**STAFF RECOMMENDATION**  
**2529 Fairfax Avenue**  
**March 17, 2021**

**Application:** New Construction—Addition  
**District:** Hillsboro-West End Neighborhood Conservation Zoning Overlay  
**Council District:** 18  
**Base Zoning:** RS7.5  
**Map and Parcel Number:** 10411013600  
**Applicant:** Alan Dooley, Architect  
**Project Lead:** Sean Alexander, sean.alexander@nashville.gov

<p><b>Description of Project:</b> A proposal to construct a side addition to an historic house. The addition will replace an existing side addition, increasing the width of the house by ten feet (10'). The addition will be one story, with a roof form and pitch matching the existing roof.</p> <p><b>Recommendation Summary:</b> Staff recommends approval of the proposed addition with the following condition:</p> <ol style="list-style-type: none"><li>1. The masonry and window and door selections are approved prior to purchase and construction.</li></ol> <p>With these conditions, staff finds that the proposal will meet the design guidelines for new construction in the Hillsboro-West End Neighborhood Conservation Zoning Overlay.</p>	<p><b>Attachments</b></p> <ul style="list-style-type: none"><li><b>A:</b>

Figure 1: 2529 Fairfax Avenue

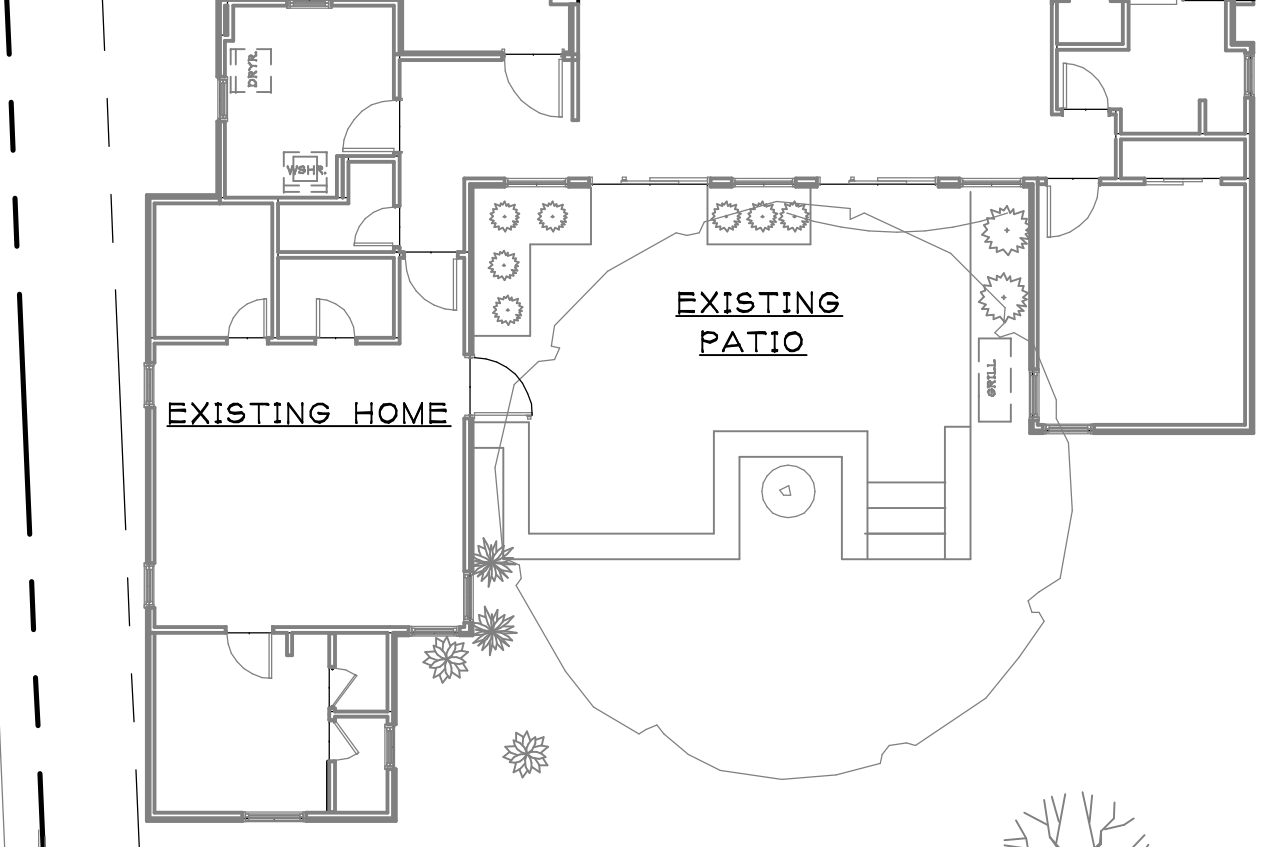
**Background:** 2529 Fairfax Avenue is a one-story bungalow with Craftsman and Colonial Revival architectural features. The house has been previously enlarged with rear and side additions, but the original form of the house is still intact. The house is on a ninety-two foot (92') wide lot, bounded on the rear and right sides by alleys. The properties across the side alley face Natchez Trace.

The house is contributing to the historic character of the district because of its age and architectural character.

Figure 2: Existing side addition at 2529 Fairfax Avenue, and existing rear addition beyond.

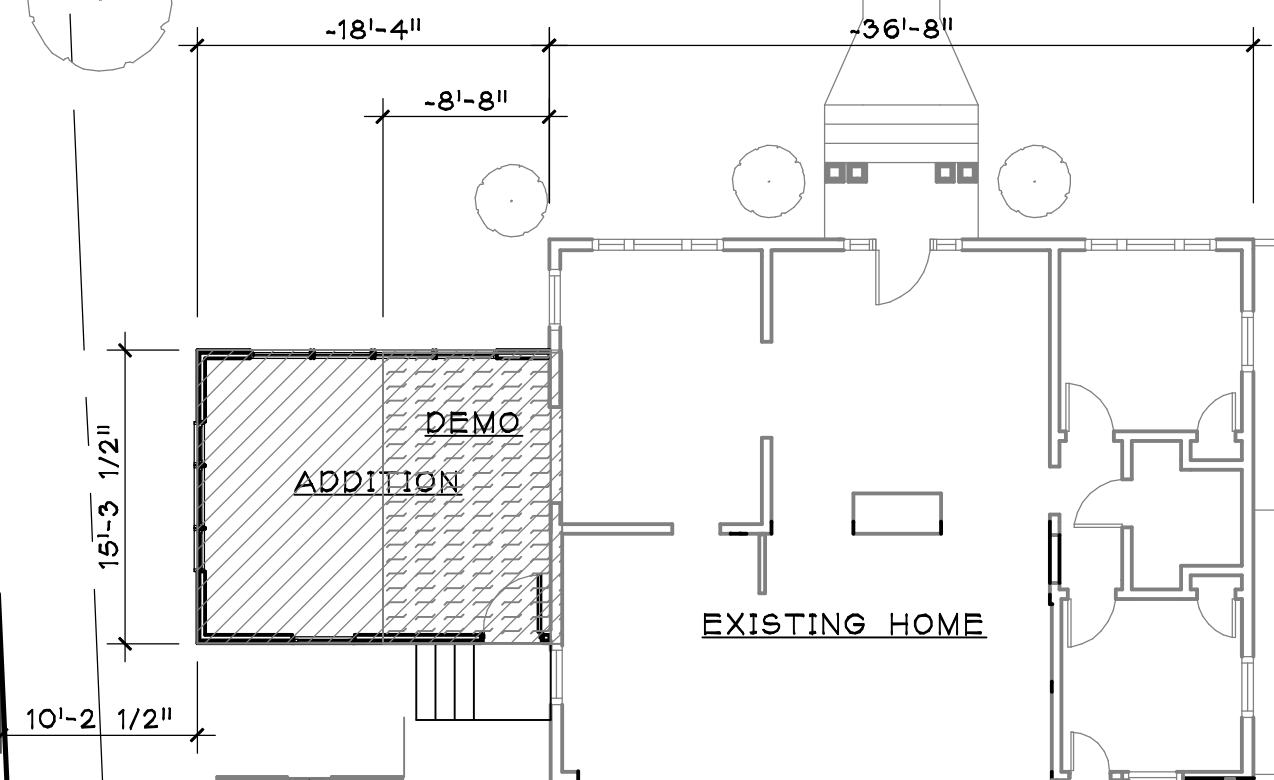
**Demolition:** The existing side addition will be demolished to accommodate the new side addition. The side addition was constructed between 1957 and 1968 and does not contribute to the historic character of the historic house. Intact portions of the historic house on the right side will not be impacted by the partial demolition.

**Height & Scale:** The addition's roof will be a side-oriented gable, tying into the right side wall of the house four feet, six inches (4'-6") below the primary roof of the house. The foundation height of the addition will match that of the historic house, but its eaves will be nine inches (9") lower. Staff finds the height of the addition to be subordinate to that of the historic house.

The addition will be eighteen feet (18') wide, which is half the width of the historic house. Staff finds the width of the addition to be subordinate to the width of the historic house.

# SITE PLAN

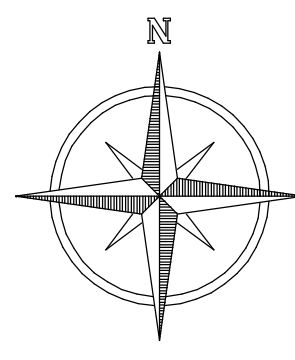
**Setback & Rhythm of Spacing:** Where the addition extends toward the right, it will have a setback of ten feet, two inches (10'-2") from the right side boundary of the property. The additional width of the addition will not have a negative effect on the rhythm of spacing along the street because the lot at 2529 Fairfax Avenue is more than fifty percent (50%) wider than the typical lot on the block, and because this house is the last house on the street. The alley to the right of this lot serves as the rear alley to houses facing Natchez Trace. In addition, a previous rear addition further back on the lot comes closer to the right side property line, which is angled in toward the rear.

The addition will sit five feet, nine inches (5'-9") back from the front of the house and will not impact the front setback.

Staff finds that the setbacks of the proposed addition are appropriate and meet Section II.B.1.c. of the design guidelines.

# FLOOR PLAN

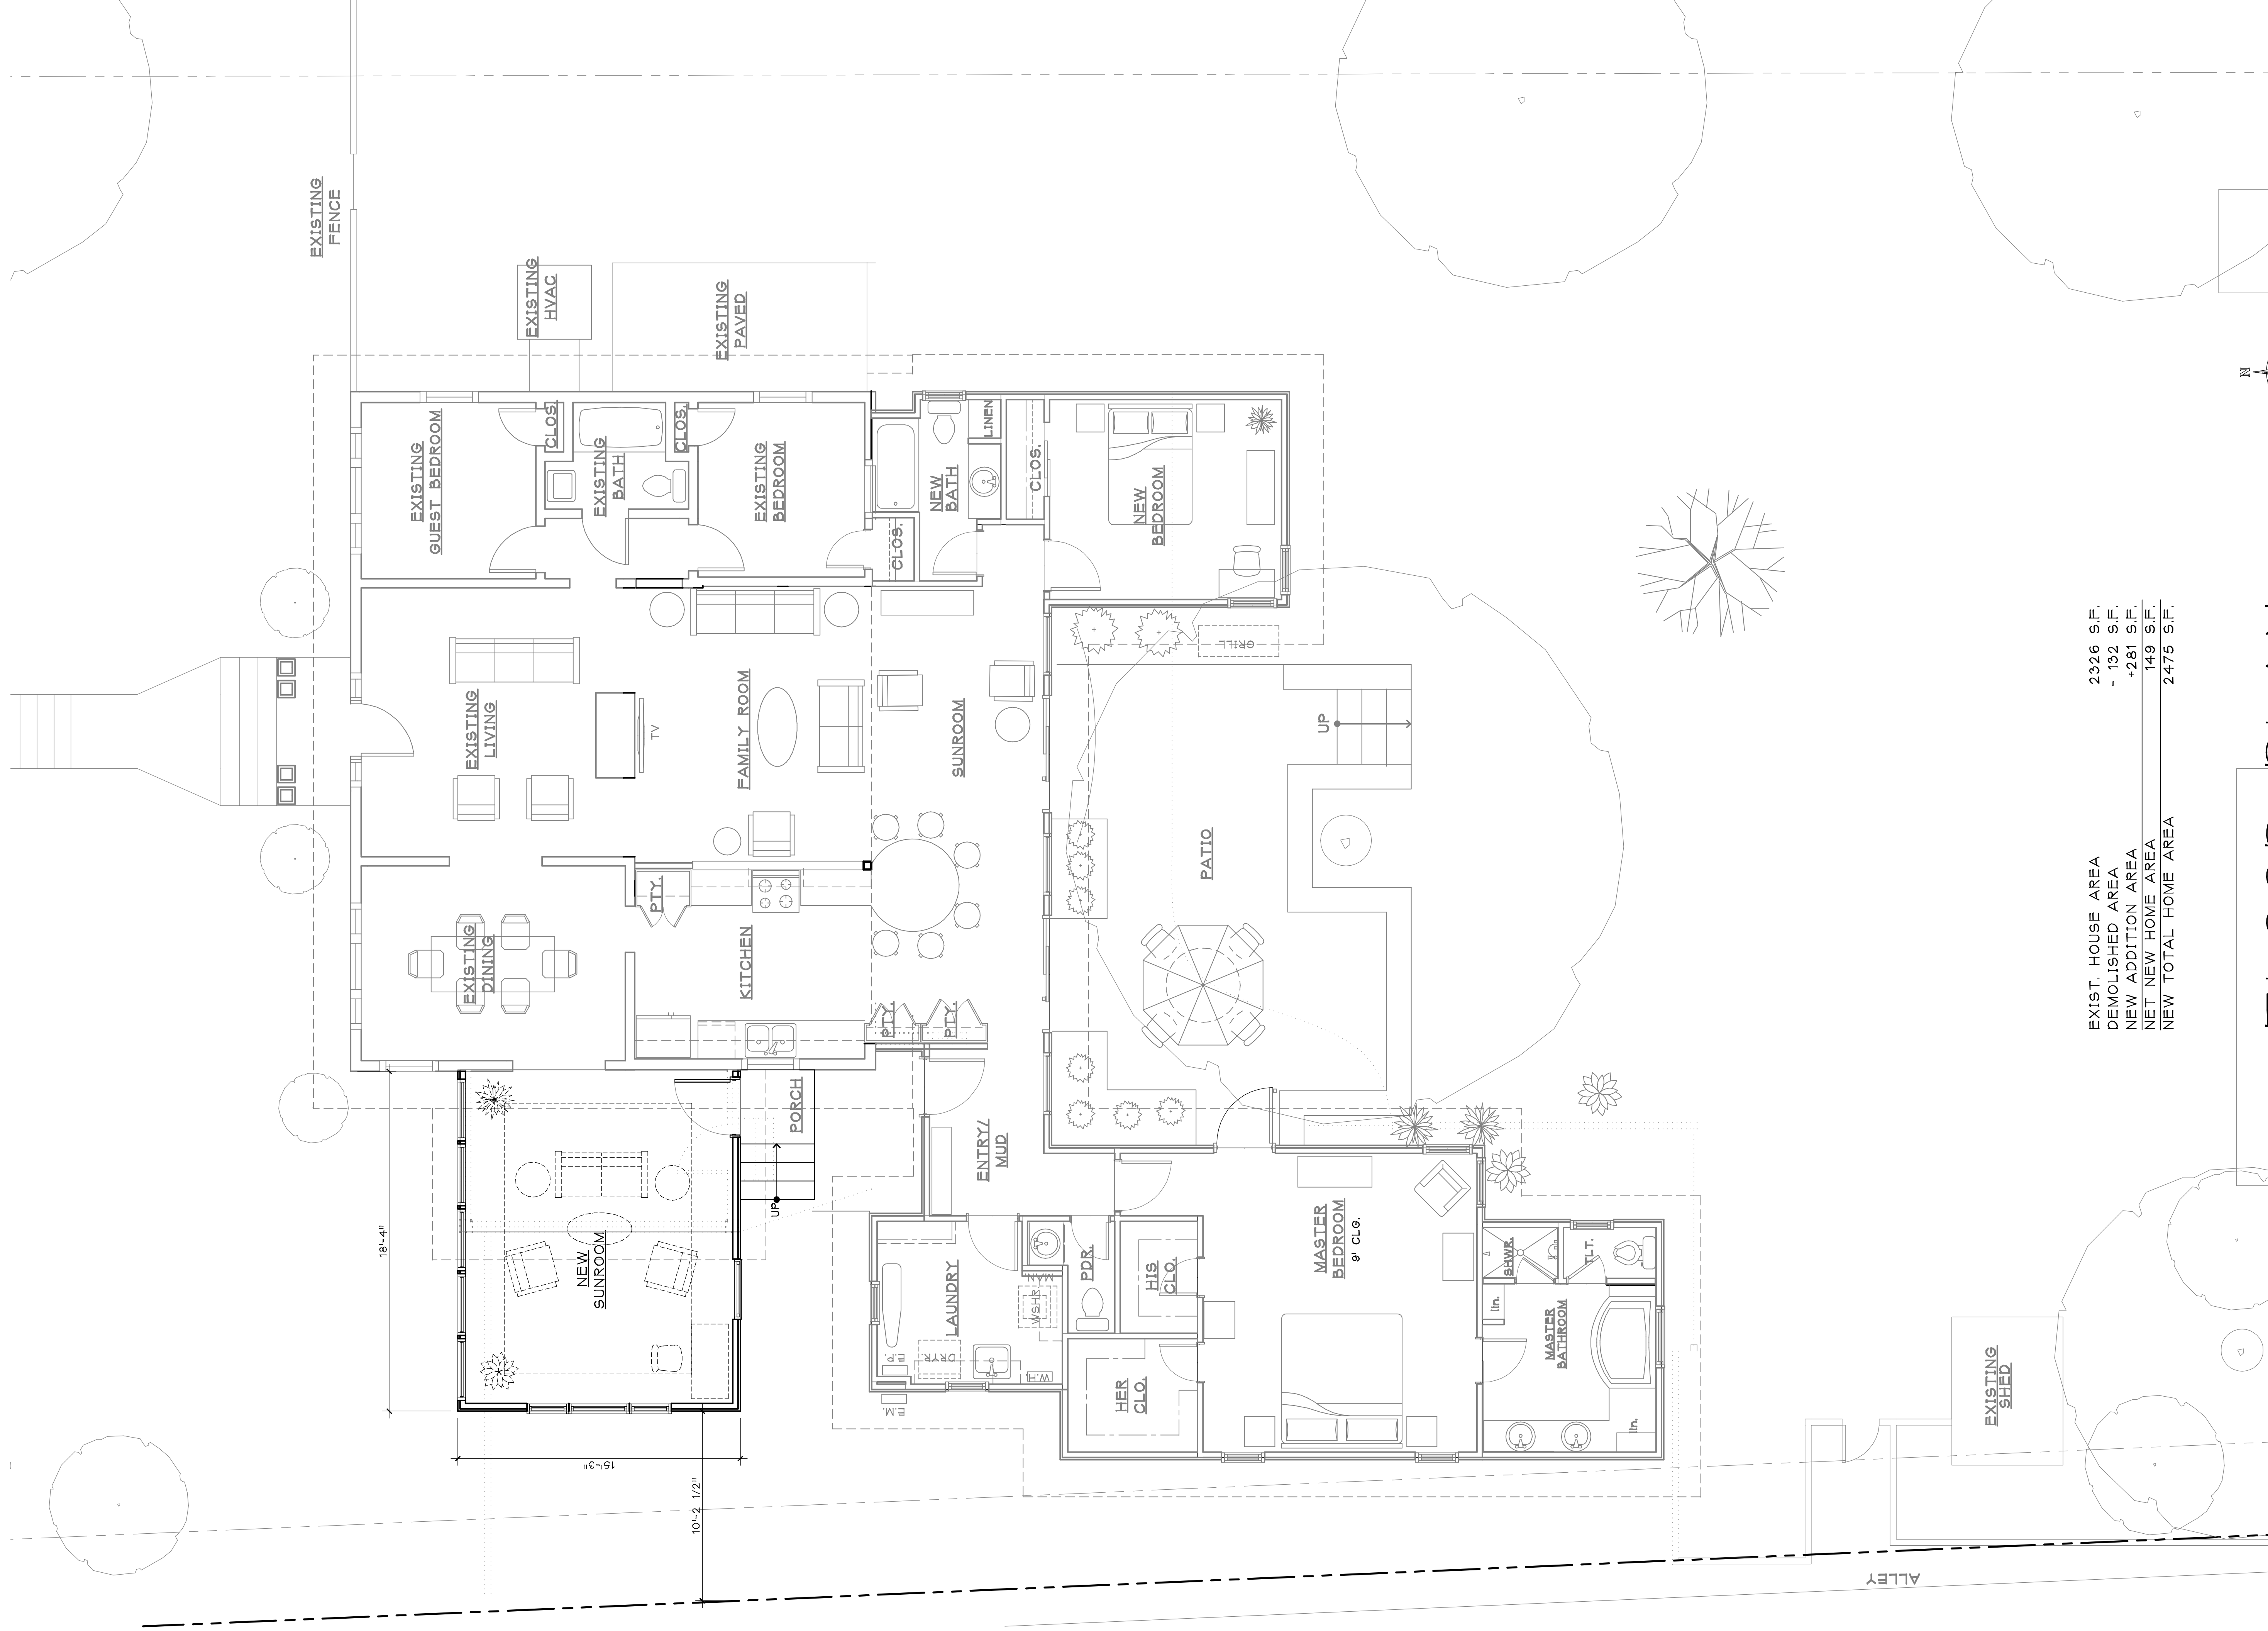
**Location & Removability:** The new addition will attach to the historic house in exactly the same location as the existing side addition, stepped from the front of the house and sitting four feet, six inches (4'-6") lower than the house's roof. Additions should generally be at the rear of an historic house, but staff finds that the proposed addition is appropriate for two reasons: because the house was previously altered with a side addition, and because 2529 Fairfax Avenue is a wide lot. The guidelines permit side additions on lots sixty feet (60') wide or greater, and this lot is ninety-two feet (92') wide.

Staff finds that the location and attachment of the addition meets Sections II.B.2.a and II.B.2.e. of the design guidelines for additions.
